PLANT NAME: Monticello

RESPONSES TO AEC

QUESTIONS ON MONTICELLO HIGH ENERGY  
LINE BREAKS OUTSIDE OF CONTAINMENT

PIPE SUPPORT - TURBINE BLDG.  
REACTOR FEED WATER PUMP PIPING:

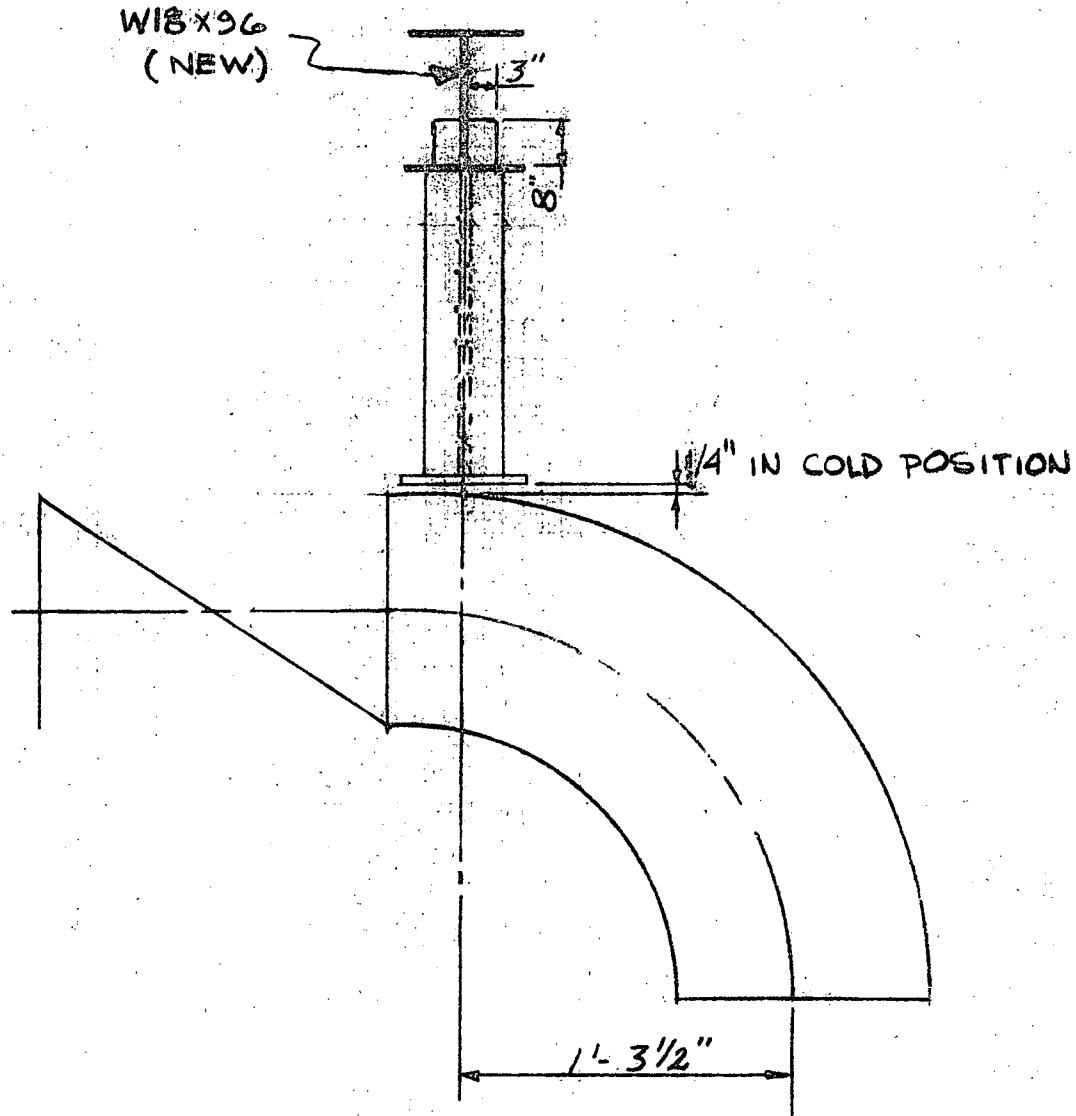
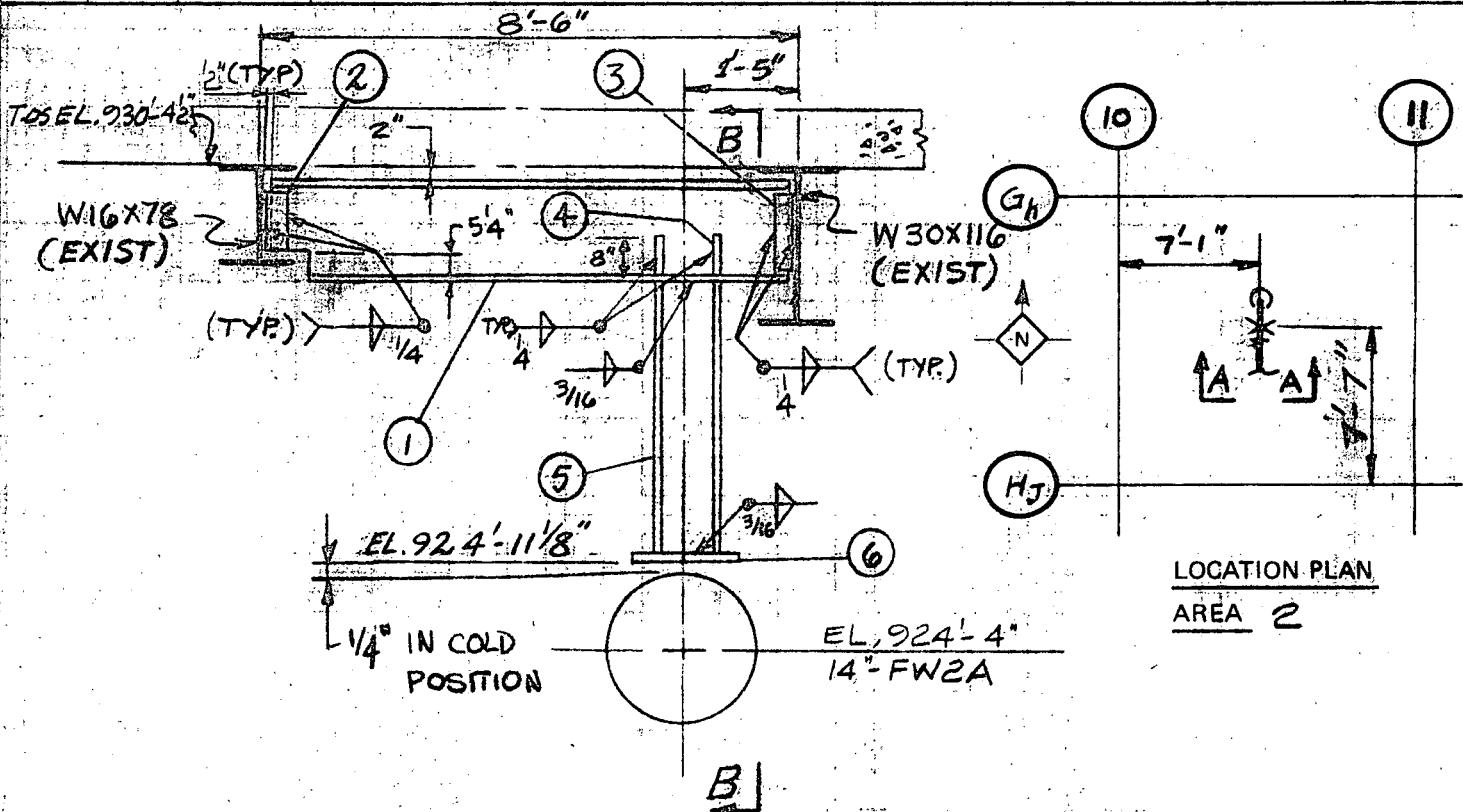
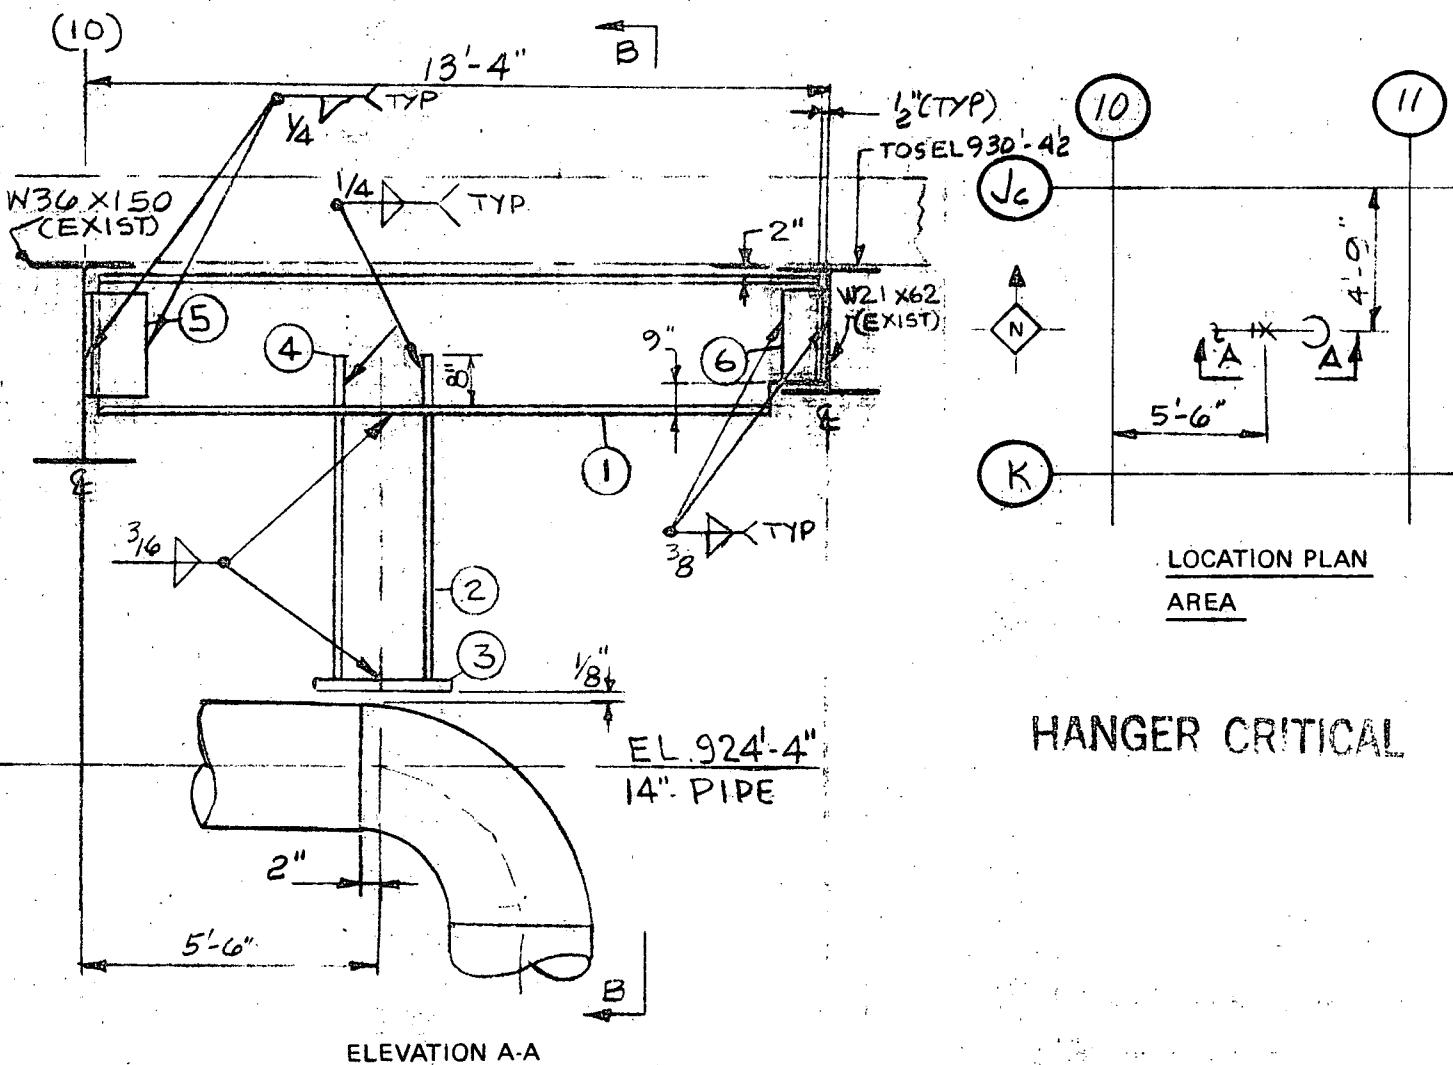
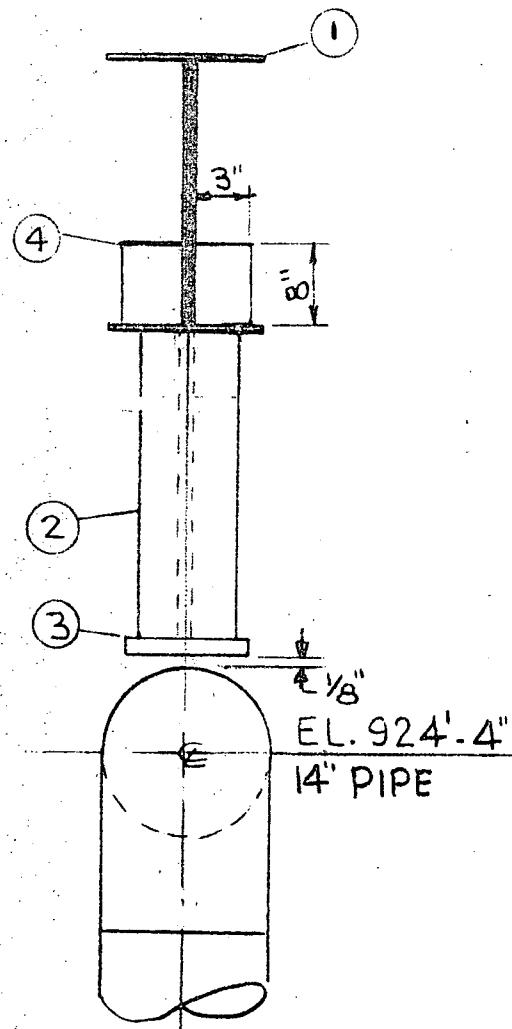
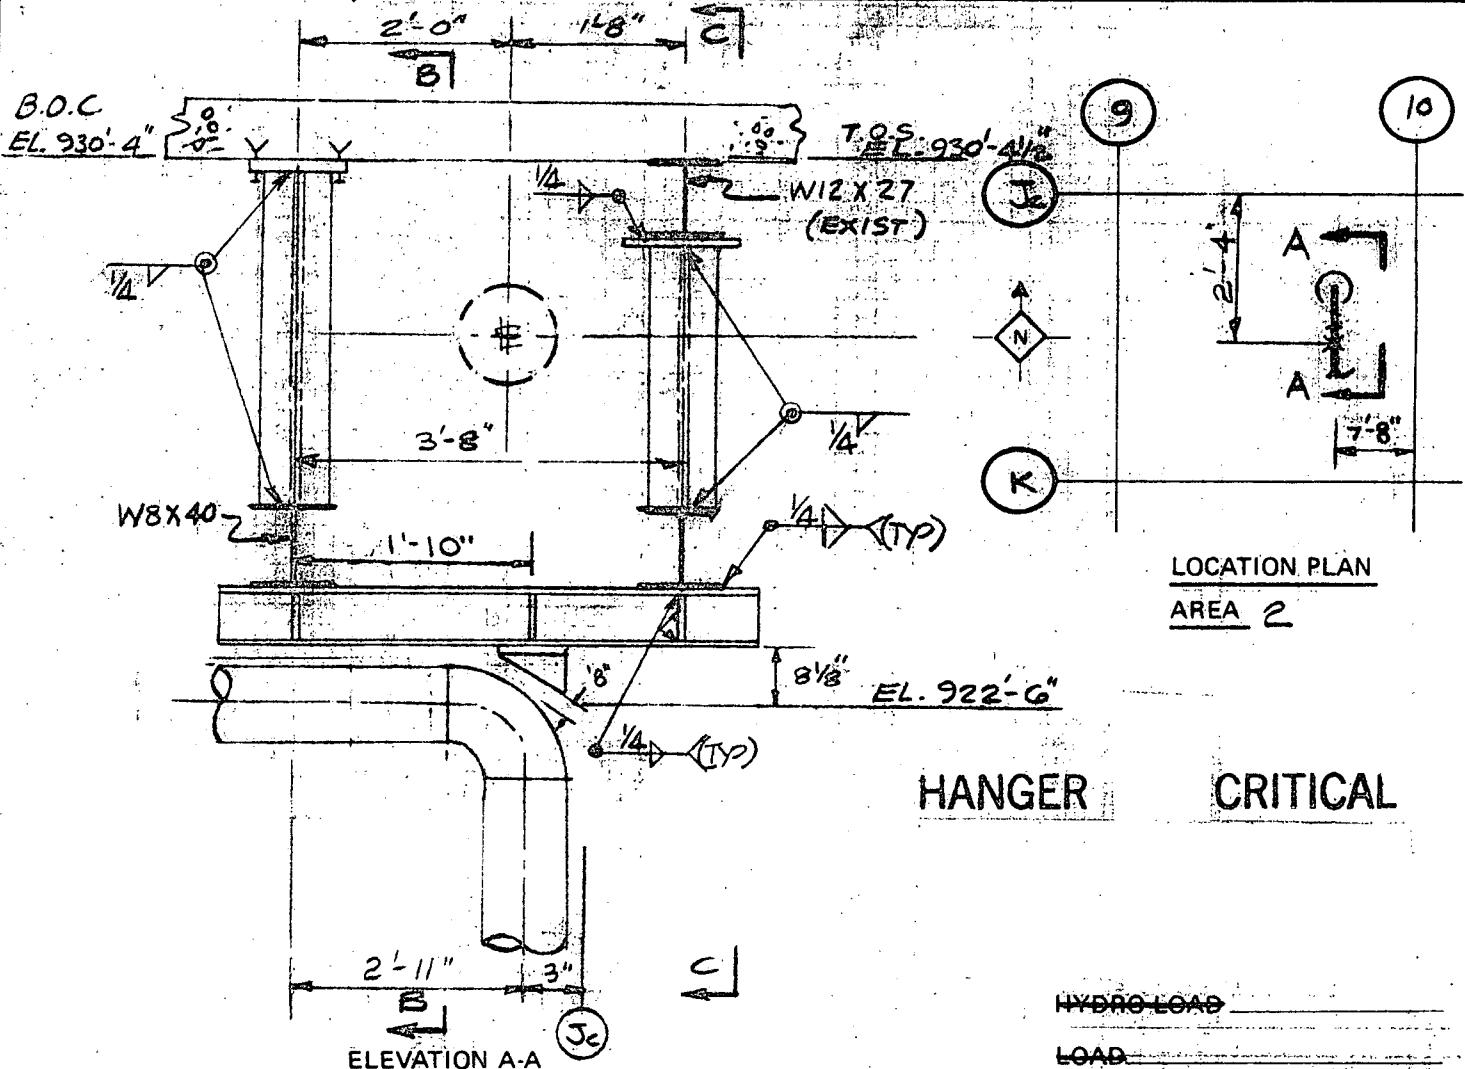
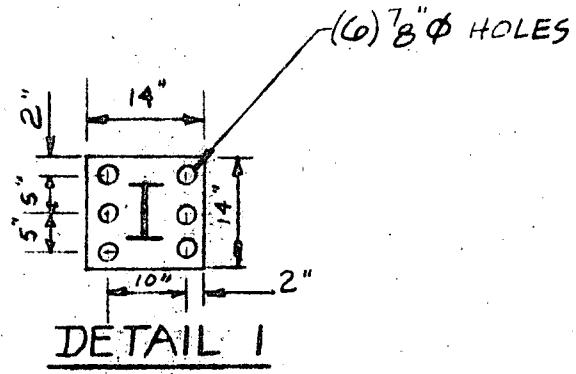
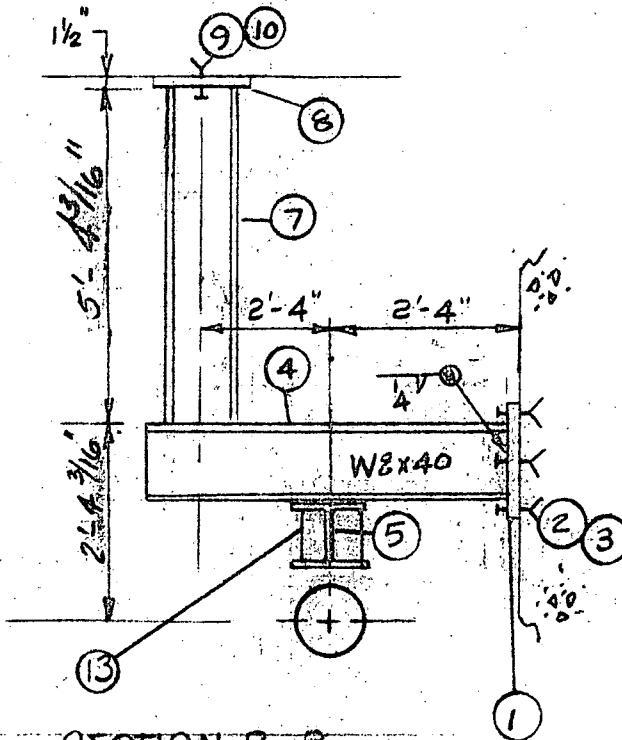
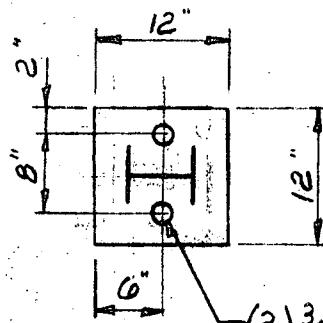
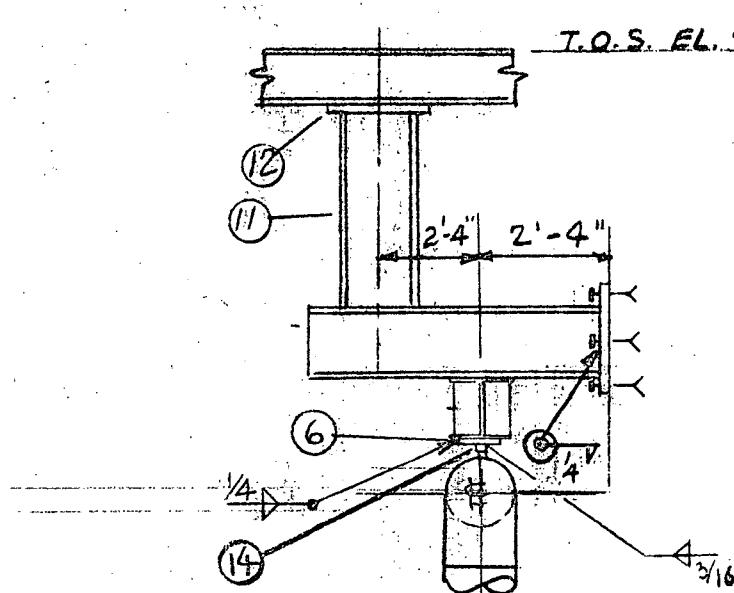
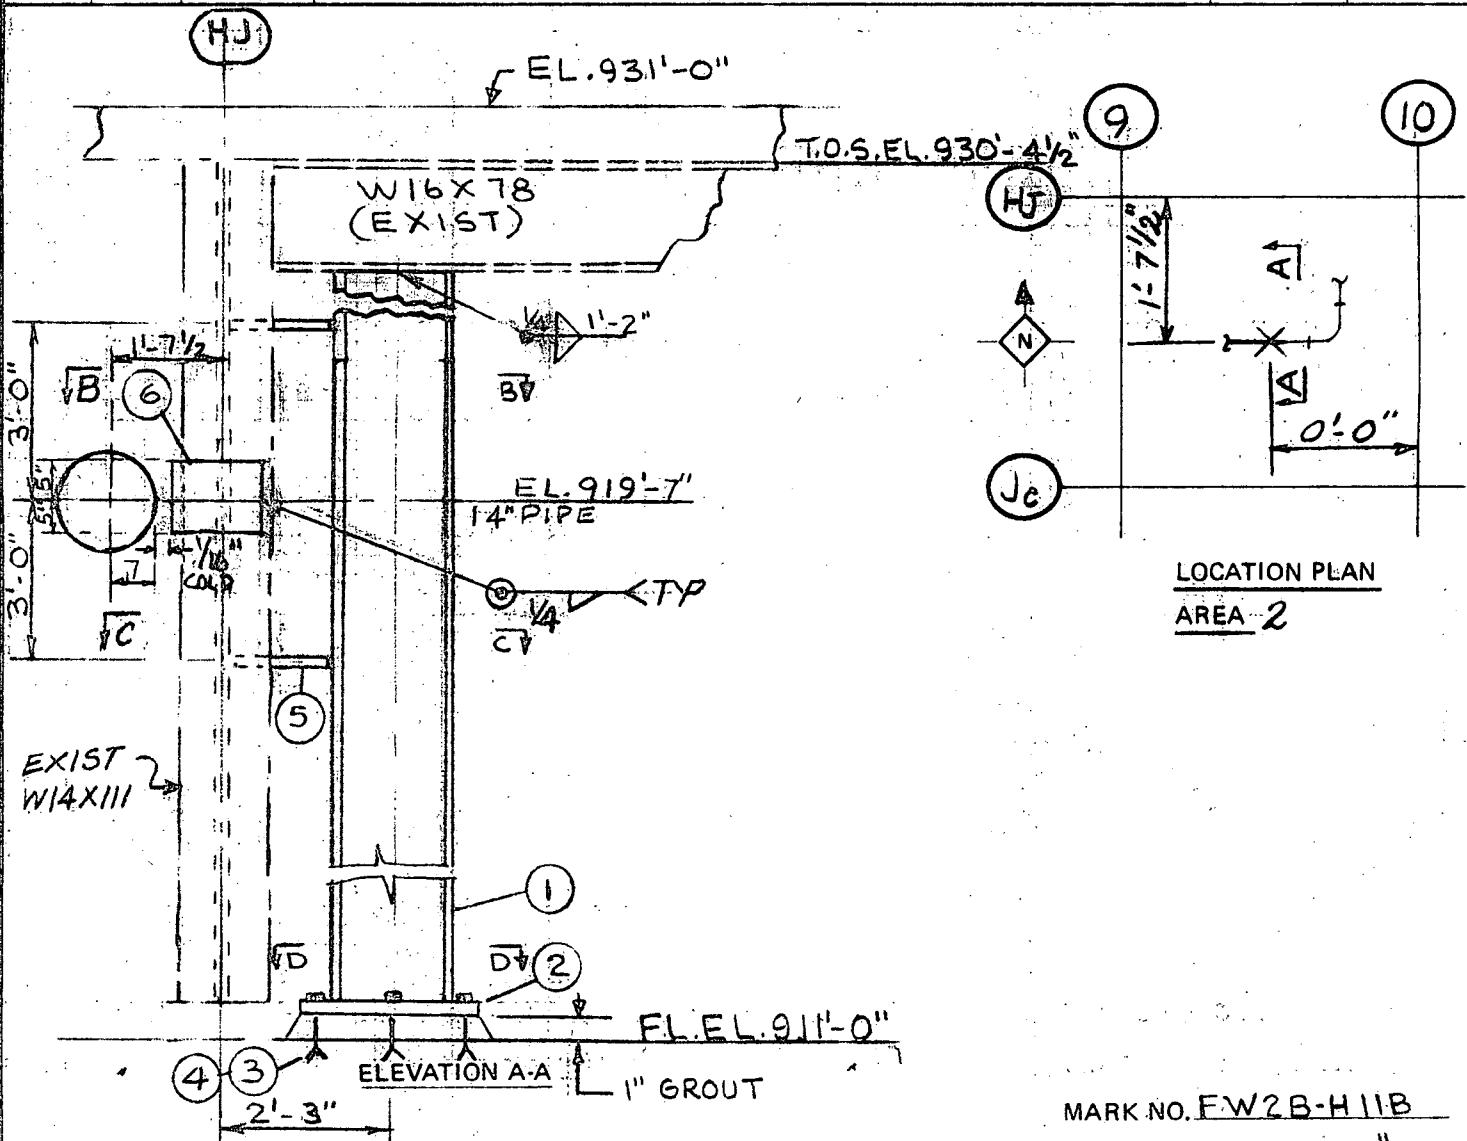
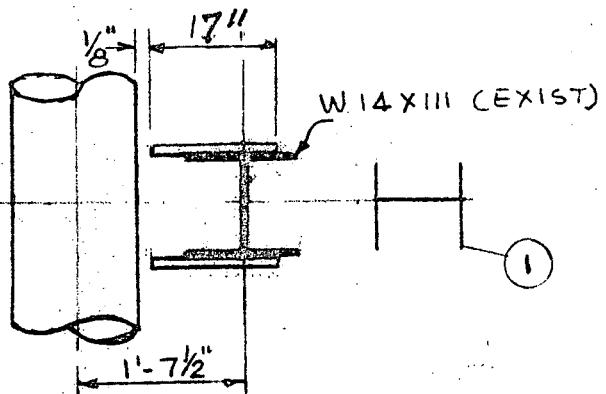
3. QUESTION: Submit details of the additional protection mentioned in paragraph 6.2.2(1).

ANSWER: The additional protection envisioned at the time of the report was a plate protecting the turbine building mezzanine floor (elevation 931'0") from a jet of water impinging on the floor. This would also have provided pipe whip protection. Further analysis of the break and break locations resulted in the following:

b. Pipe Whip

In order to provide protection to the mezzanine floor against pipe whip, four restraints will be added. Detail drawings of the pipe restraints are attached. The design load for the pipe restraint was 161 kips.

With the addition of the four pipe restraints, the mezzanine floor will be protected; thereby insuring safe shutdown of the plant following a feedwater line break.
